SOLICITATION ADDENDUM NO. 2

Project Title	Date Prepared	Project No.
SJCCD Maritime Expansion Fire Training Center	December 4, 2019	CSP 20-12

ADDENDUM NO. 02

Project: **Maritime Expansion Fire Training Center**
 San Jacinto Community College District

CONSULTANTS
 STRUCTURAL
 CSF Consulting LP
 11301 Fallbrook Suite 320
 Houston, Texas 77065
 Tel: 832.678.2110
 Fax: 832.678.2115

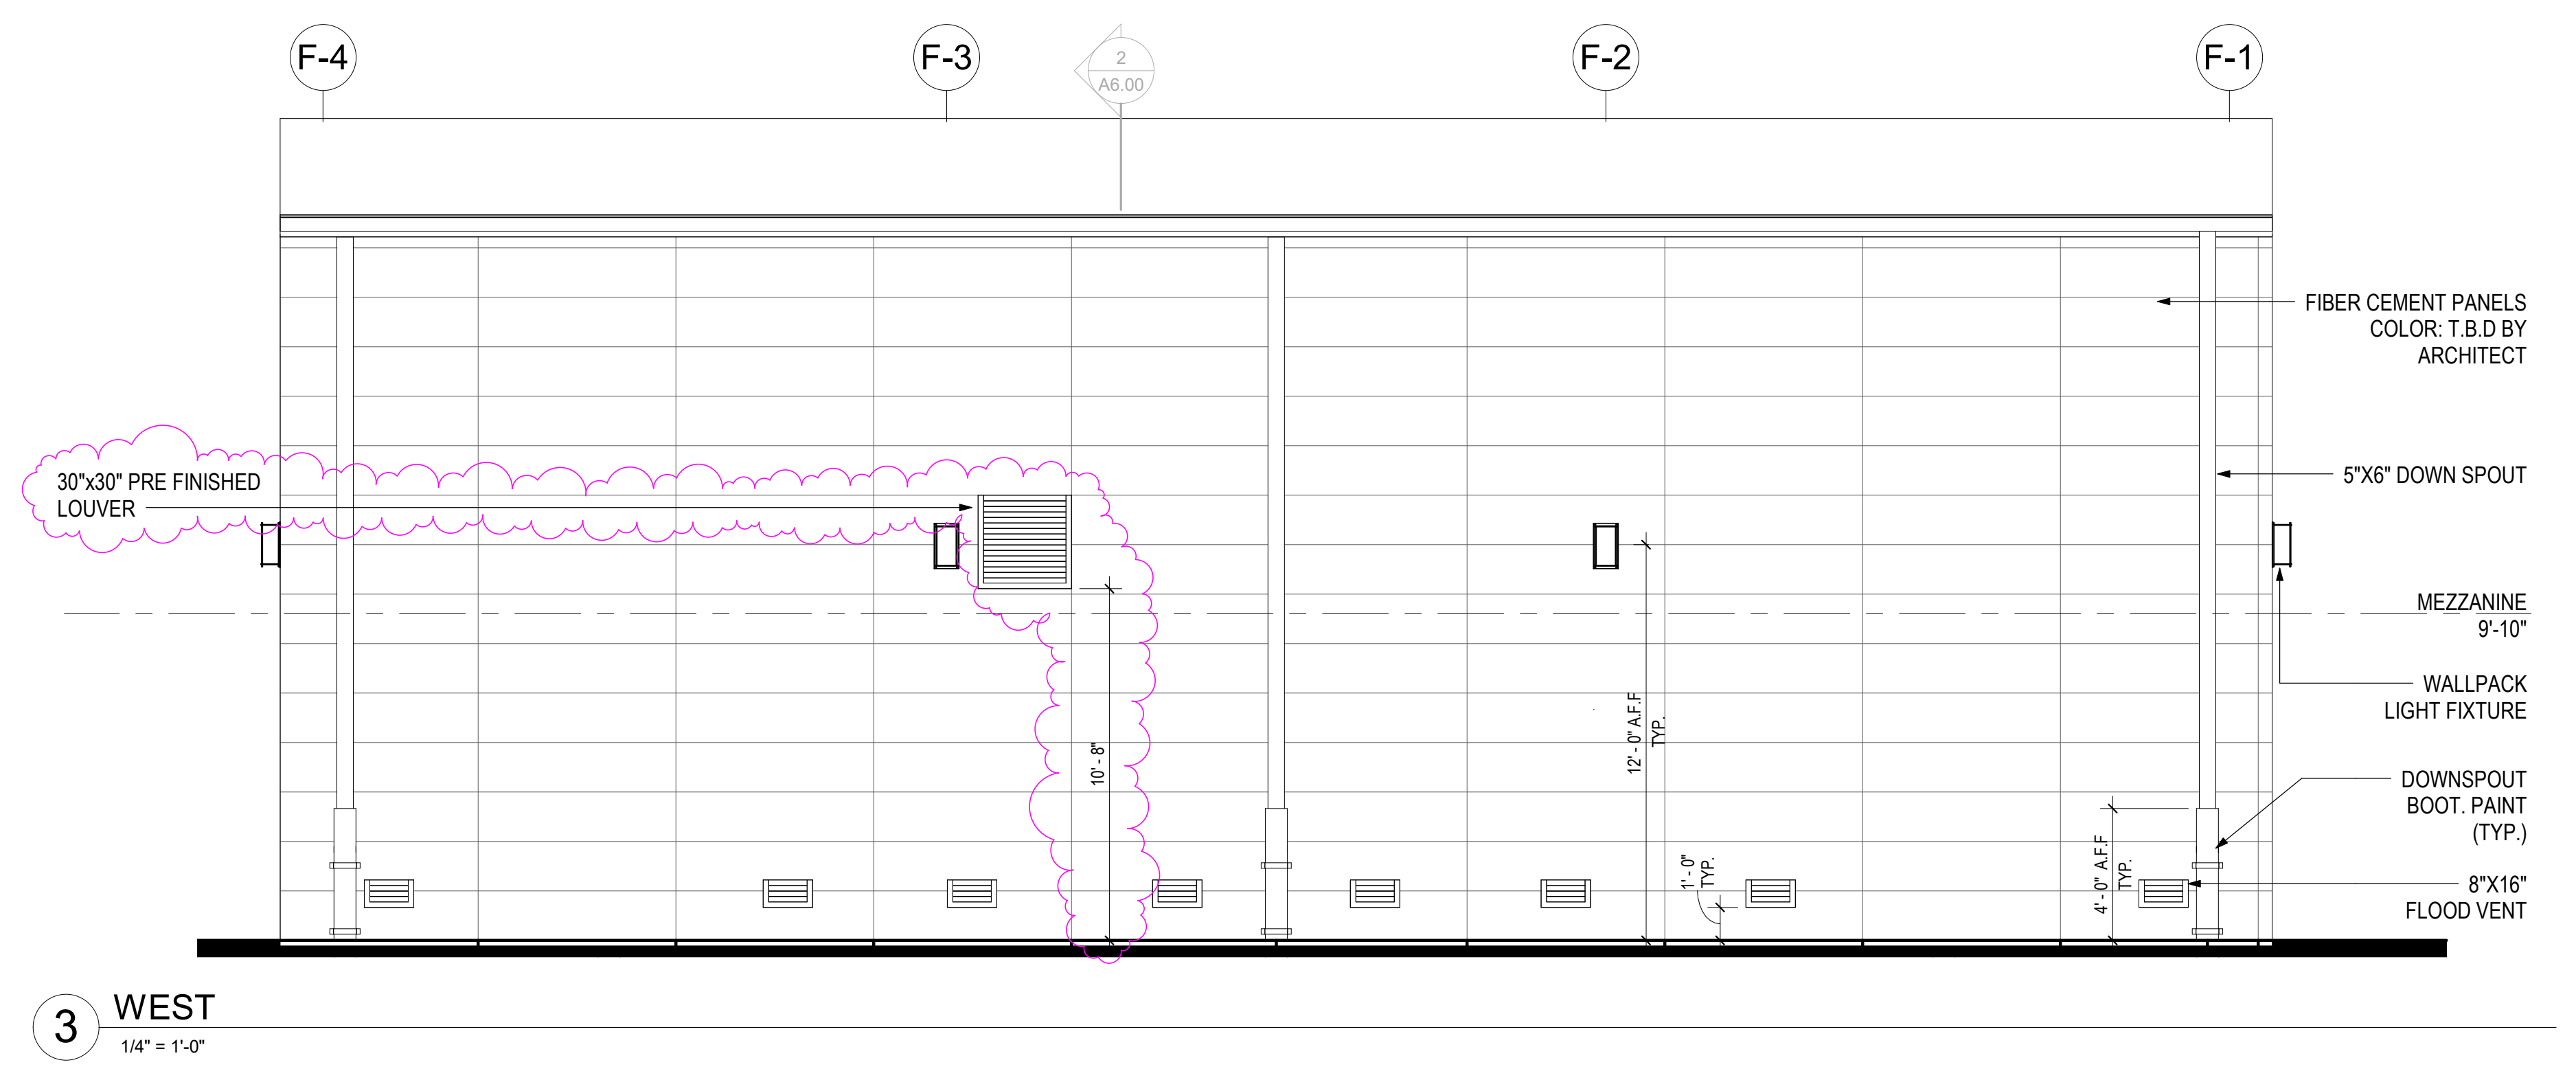
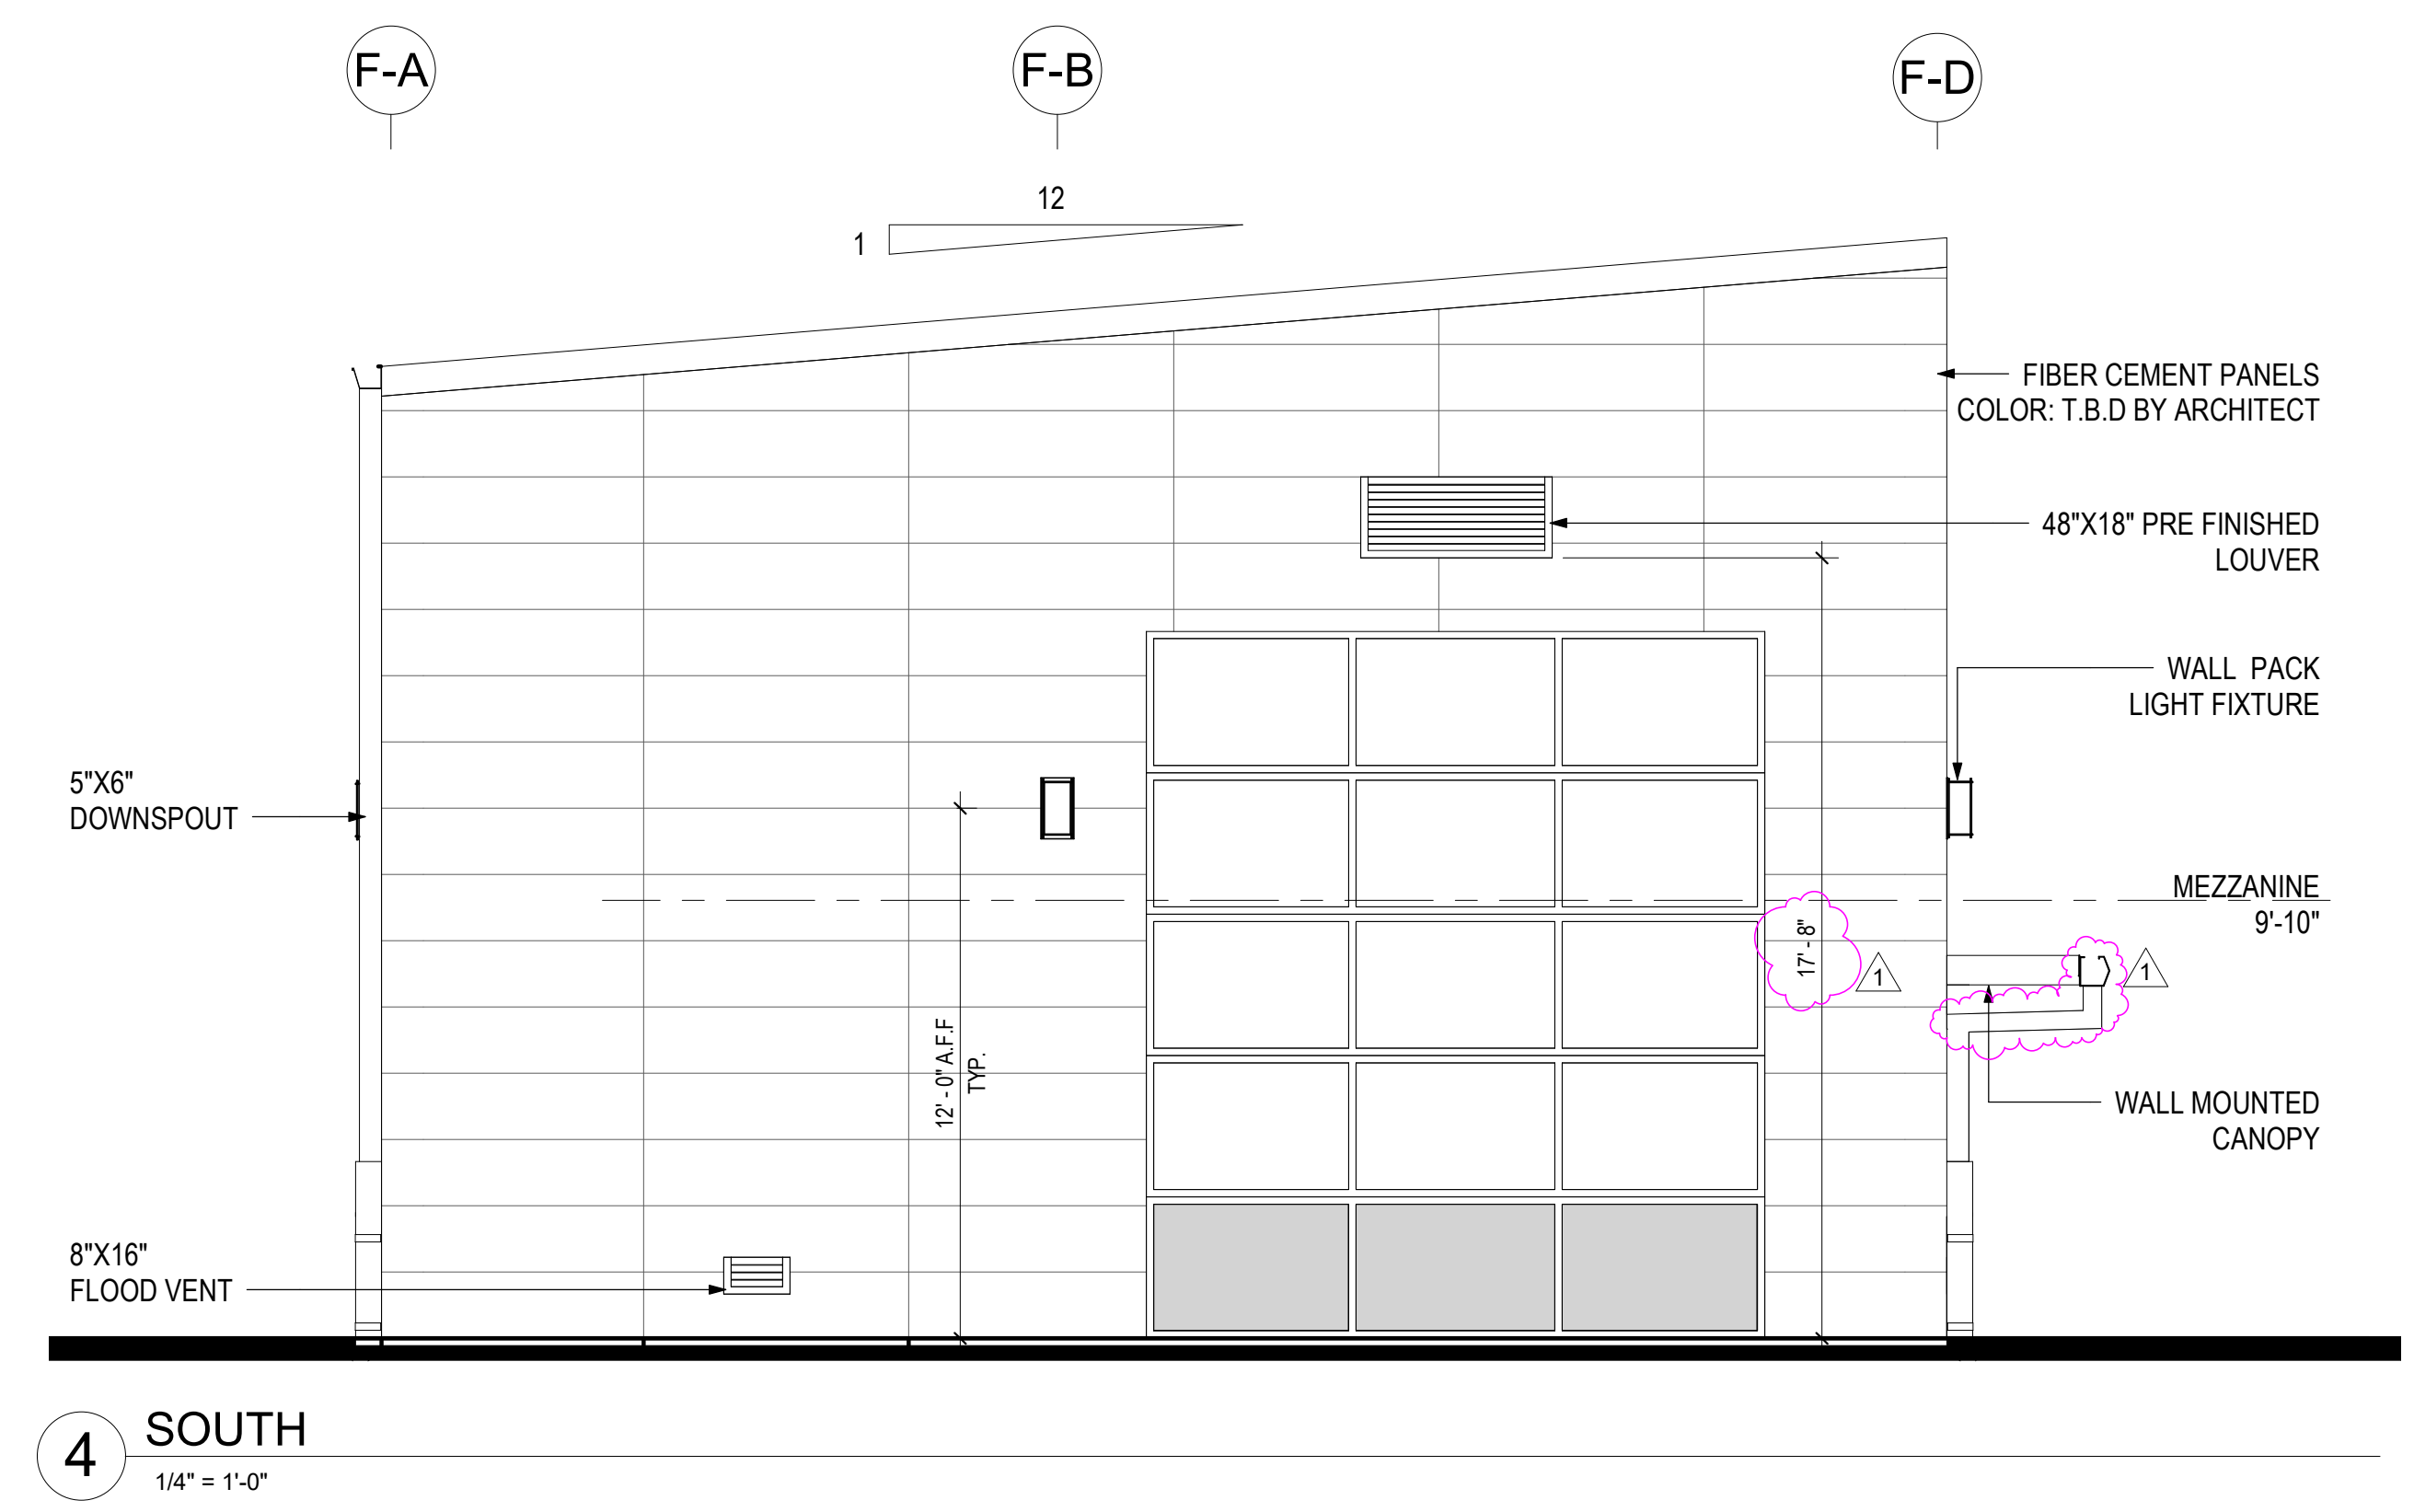
20. Sheet A7.01 – Exterior Elevations
 - a. On details, 2 and 4 the louvers heights were adjusted.
 - b. On details, 2 and 4 the downspout is revised to match detail 7/6.00.
 - c. An Additional louver has been added on detail 3.
